N1921A-02A

S E R V I C E N O T E

Agilent P-series Wideband Power Sensor

Loose bulkhead (N1920-60004)

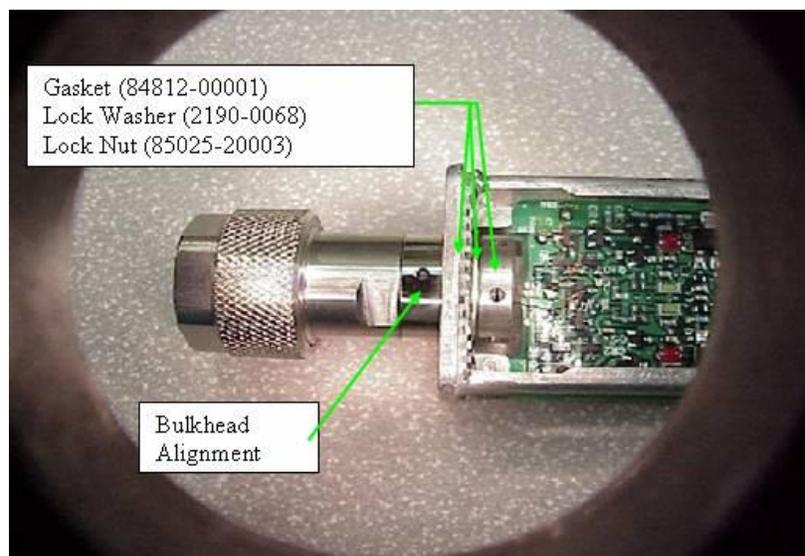
Loose bulkhead (p/n: N1920-60004) for P-series wideband power sensor built in US. Kindly send it to local service center for rework.

1. Screw lock nut 85025-20003 onto threaded end of bulkhead assembly. Apply loctite (0427-0231) on the first, second and third threads of the end of the bulkhead (as shown in the figure below):

2. Torque lock nut to 28 in. -lbs. with T-314592.

3. Calibrate the unit after the above changes are applied.
